Substantive response of the Local Highway Authority to a planning consultation received under The Development Management Order.

Planning Application Number: 24/00274/FUL

Application Address: Manor View Aston Flamville Road Burbage Hinckley Leicestershire LE10 3AA

Description of Application: Re-consultation. Extensions and alterations of existing ancillary building to form early years day nursery (Class E) with associated car parking

Figure 1: Northwestern visibility splay.

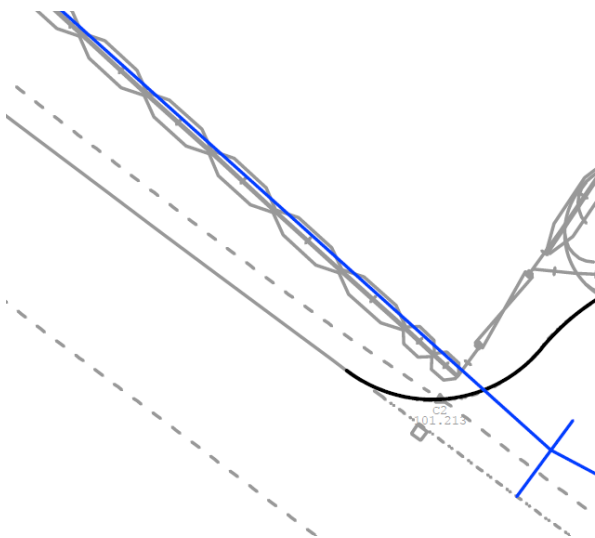
The LHA previously advised to the northwest, the visibility splay appeared to cross third party land i.e. the neighbouring field, and was obstructed by the existing hedgerow, which also restricted the available visibility on the site visit. The Applicant's revised drawing, which shows the visibility splays off-set 1.0m into the carriageway, still appear to show the visibility splay (blue line) falling within third party land and being obstructed by the neighbouring hedgerow, as shown in Figure 1 below.
